ADDENDUM NO. TWO

DATE: October 23, 2025
DEPARTMENT: People and Internal Operations Department (PIOD)
PIOD PROJECT NAME: REG Justice Center 9th FL Vault Expansion
PIOD PROJECT NUMBER: I190406
BID DUE DATE: **November 4, 2025 (REVISED)**
CONTRACT COORDINATOR: Kristina Hagberg

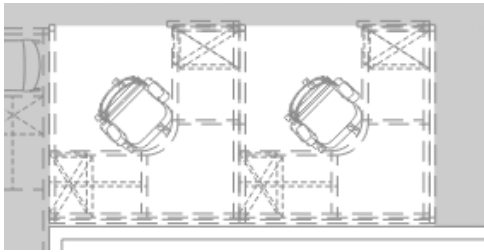
Q12. Will the contractor have a designated staging area?

A12. No, space is limited.
